**ARTICLE 200 — USE AND IDENTIFICATION OF
GROUNDED CONDUCTORS**

5-13 Log #1009 NEC-P05 **Final Action: Accept**
(200.6(B))

Comment 2-125 (Log #2211)

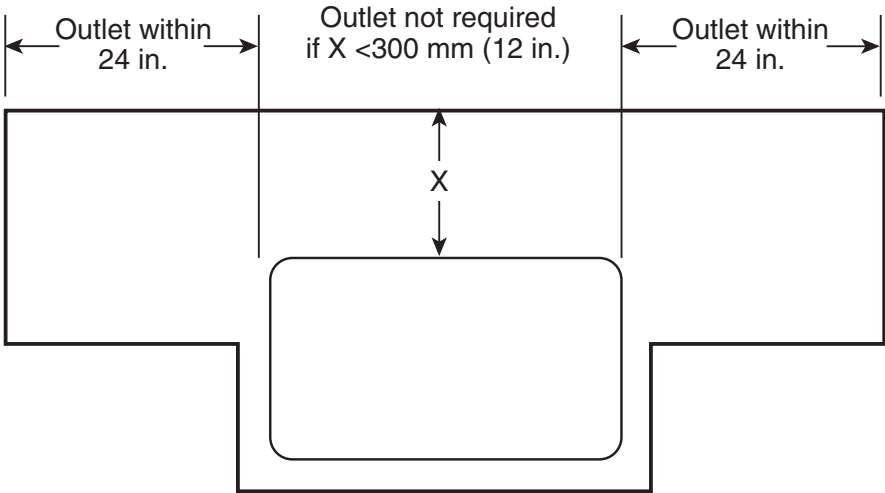
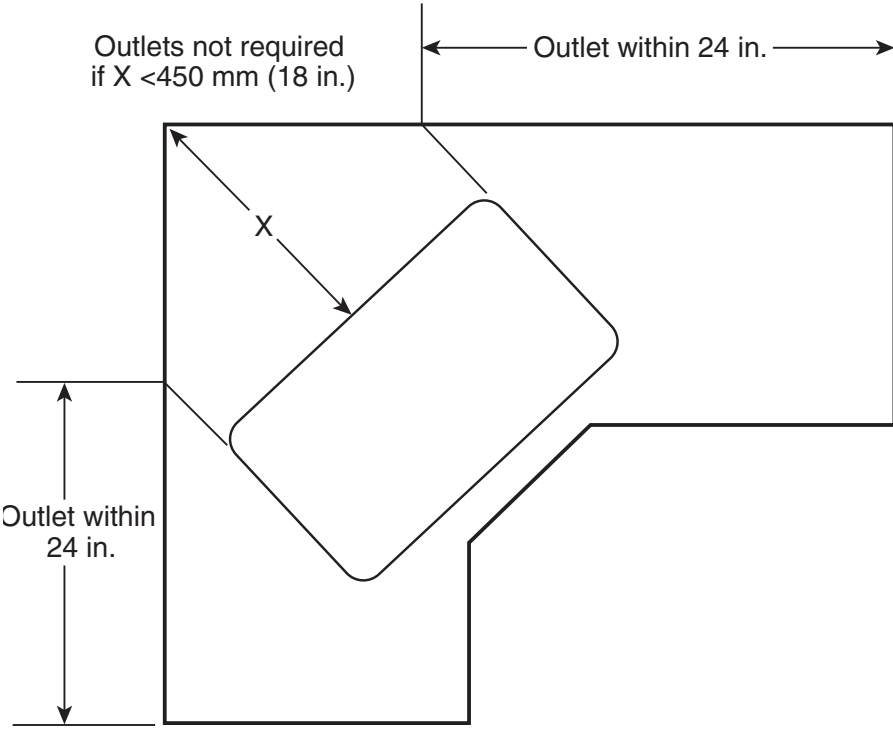
Recommendation: Accept the proposal in principle. Make the following changes in Figure 210.52:

Modify Figure 210.52 as follows:

Substantiation: Figure 210.52 (2-211a) on page 2787 in the ROP. When the sink or range top are located in a corner and the counter space is accessible by means of a breakfast bar, this area is usable counter top space and a receptacle is needed. Many times there is a receptacle installed for a toaster, radio or even a television. I inspect almost 300 homes every year and this configuration is very common and without this receptacle, we will see short extension cords used for these portable appliances. Please see my attached diagram showing the wall on one side and the peninsula/breakfast bar with the sink in the corner.

Panel Statement: Modify figure as suggested; also modify exception text to read “Receptacle outlets shall not be required on a wall directly behind a range or sink in the installation described in Figure 210.52.
